Transbay Transit Center
San Francisco, CA
CM/GC Contract No. 08-04-CMGC-000
Project No. 30100

**BID PACKAGE TG07.9
ADDENDUM # 6**

TG07.9 – Bollards and Barriers

3
-
SIDE ELEVATION VIEW
SCALE: NTS

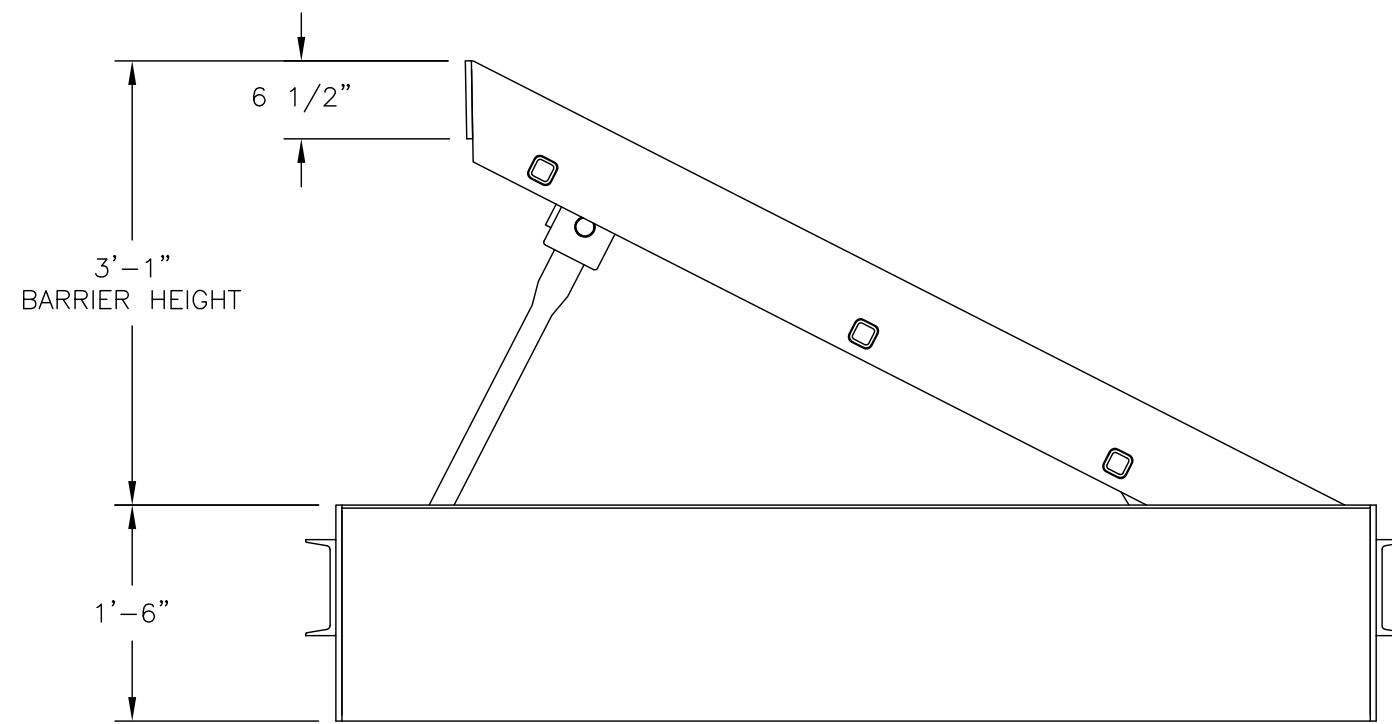
Question No.	Submission Date	Drawing No.	Document/ Spec. No.	Question	Response
TG07.9-001	8/20/2014		ASI 121 28 16 44	We respectfully request that proprietary M50 rated active vehicle wedge barrier (SW 1900) be added to the approved manufactured list. Please see attached documentation.	FutureNet is an acceptable manufacturer of phalanx barriers and operable bollards. The Trade Subcontractor will be required to submit specific product data for the FutureNet barriers they intend to provide that meets the criteria identified within Specification Sections 28 16 44 and 28 16 44/APA.

DRAWING TITLE: **Response to RFI TG07.9-030 Locations of Bollards B1B, B1C, BOL-5**

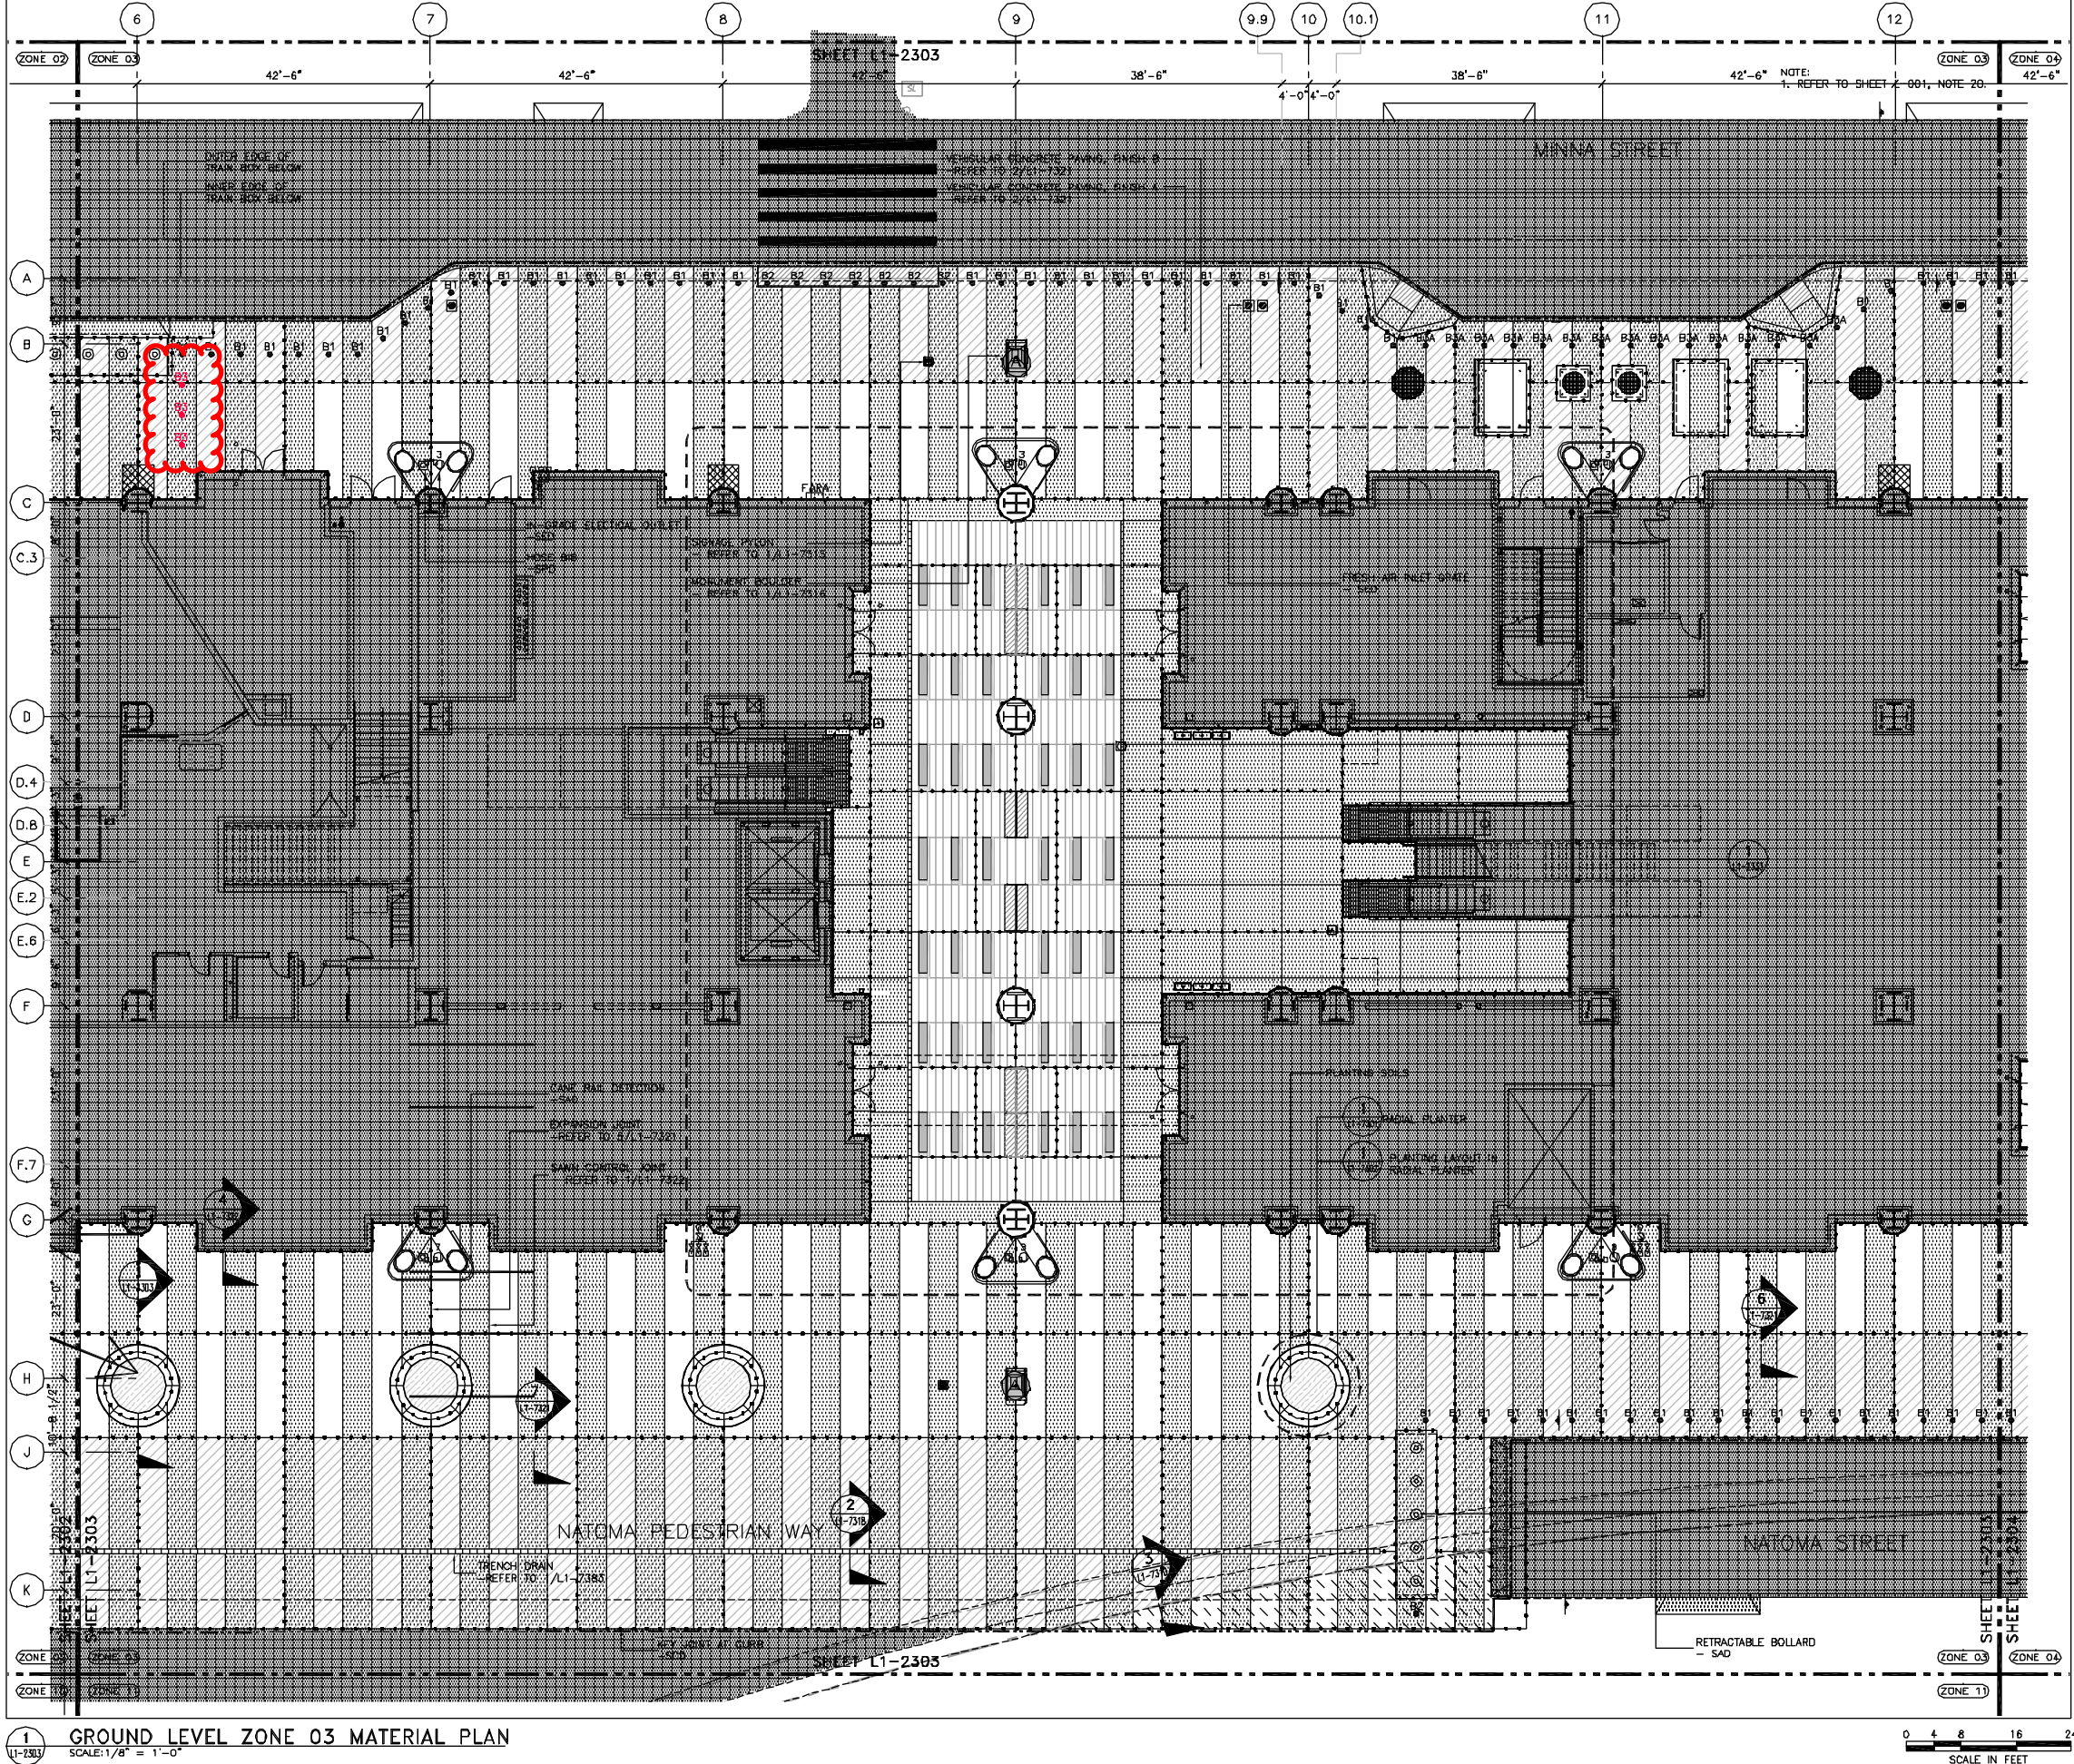
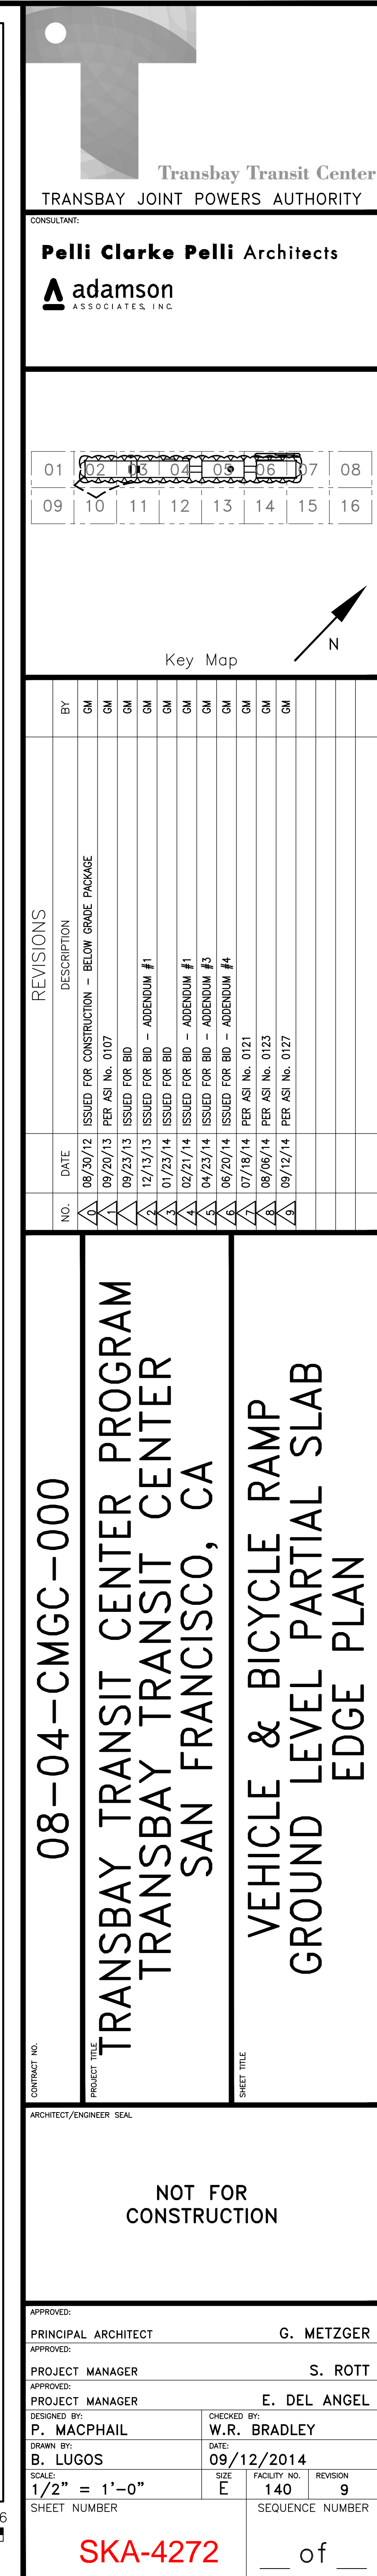
Question No.	Submission Date	Drawing No.	Document/ Spec. No.	Question	Response
				Please clarify the maximum depth of the operational bollard frame from top of grade to resting point of the bollard frame?	<p>the resting point of the bollard foundation/frame can be derived by referring to the following drawings read in conjunction:</p> <p>a. Architectural drawings – For ground floor TOC elevations and slopes, refer to ground floor slab edge plans on A1-2862, A1-2863, and A1-2864.</p> <p>b. Structural drawings – For ground-floor structural slab elevations from the building line to the foundation wall, refer to ground-floor framing plans on S1-2302, S1-2303, and S1-2304. For moment-frame beam depths, refer to ground floor moment frame beam schedule on S1-3600; and for ground floor slab thickness, refer to concrete slab schedule on S1-3500.</p> <p>c. Landscape drawings – For ground floor sidewalk grading, refer to ground level grading and drainage plans on L1-3302, L1-3303, and L1-3304. For ground-floor sidewalk thickness, refer to ground-floor material plans on L1-2302, L1-2303, and L1-2304. Also refer to sketches attached with the response to RFI TG07.0-030 (SKLA 325 RFI TG07.9-030 Location of Bollards Consolidated.pdf)</p>
